Agenda – Council – June 21, 2017

Item No. 4 **Development Agreement Amendment AG 50/13 – Ridgewood South, Opposite Cardiff Avenue and North of CNR Mainline – Ridgewood West Land Corp.**
(Charleswood-Tuxedo-Whyte Ridge Ward)
File DASZ 50/2013

Title: **DEVELOPMENT AGREEMENT AMENDMENT AG 50/13 (C/R DASZ 50/2013)**
SUBDIVISION AND REZONING – RIDGEWOOD SOUTH, OPPOSITE CARDIFF AVENUE AND NORTH OF CNR MAINLINE – RIDGEWOOD WEST LAND CORP.

APPENDIX "A"

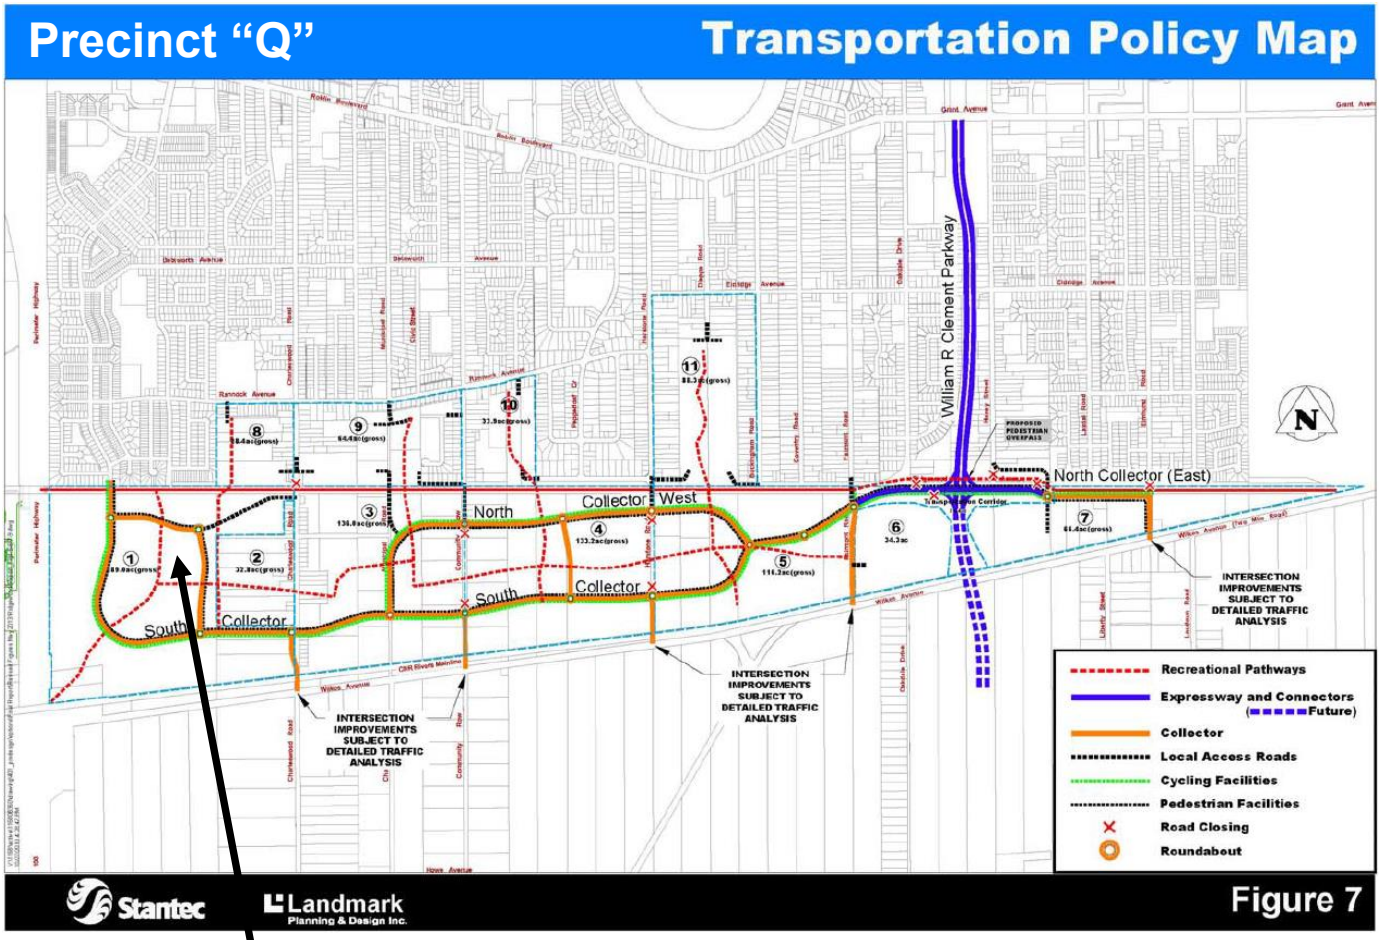
This clause inherently requires the developer to construct 1.5m wide asphaltic concrete bicycle paths in all Collector Streets in the Planned Area which is not consistent with Precinct Plan “Q”. Figure 7 (see Appendix “A”), shows cycling facilities (bike paths) to be constructed in the South Collector and the North Collector streets only, and not in north-south Collector Streets such as, in this case, McKellar Drive.

We are requesting to amend this clause as it contradicts the statutory precinct plan figure 7 (attached) and the original intent of the cycling facilities to be provided by the developers in the precinct. I've asked the authors of the report, Landmark Planning and Stantec Consulting for clarification of the intent of the precinct plan and have attached their response to this letter as support of our application.

To fix this, it is recommended that the words ***“, except that a 1.5m wide asphaltic concrete bicycle path will not be required to built in McKellar Drive” . . .*** , be added to Clause 10. a) after the word greater, such that Clause 10. a) reads as follows;

a) construct a 1.5m wide by 100mm thick Portland cement concrete sidewalk and a 1.5m wide asphaltic concrete bicycle path on the standard alignment, 0.3m from the property line, along both sides of all streets within the Planned area with rights-of-way measuring 22.0m in width or greater***, except that a 1.5m wide asphaltic concrete bicycle path will not be required to built in McKellar Drive****. . .;*

Development Agreement AG 50/13 Planned Area

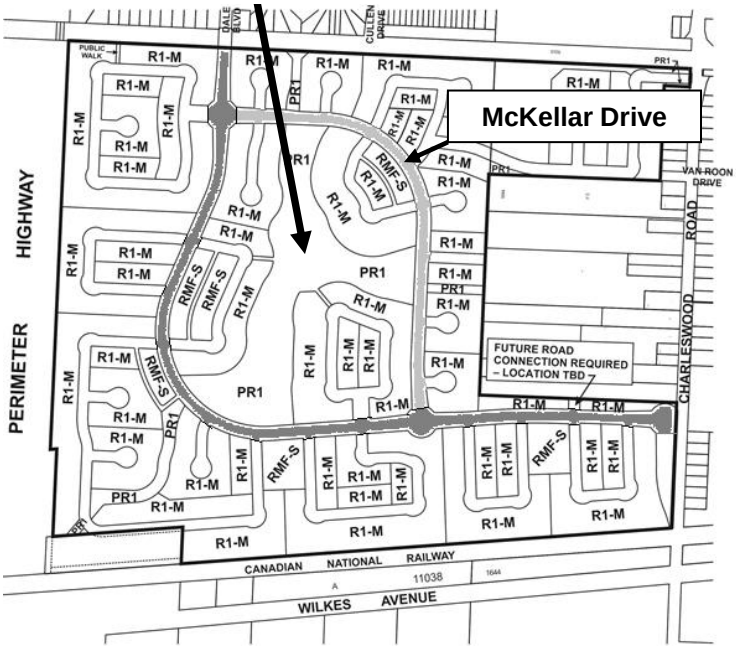
The City entered into Development Agreement AG 50/13 with Ridgewood West Land Corp. effective February 26, 2014 to develop Area 1 of Precinct Plan “Q”.
